NUMBER: 21-008-15 REV. A

GROUP: Transmission and Transfer Case

Transmission Shift Quality C-Clutch Snap Ring

This bulletin involves removing the transmission, disassembling, and replacing the C-Clutch snap ring.

Fig. 10 Snap Ring Orientation

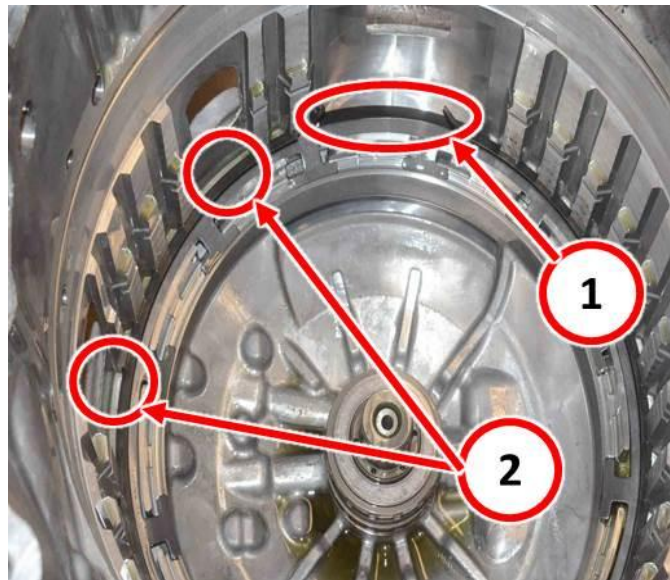
NOTE: The new C-Clutch snap ring will be installed with the opening in a different position from the original.

34. Install the new snap ring with the opening rotated 90 degrees counter clockwise from the original snap ring location. See (Fig. 10) and (Fig. 11).

1 - Original snap ring opening installation location

2 - New snap ring opening installation location
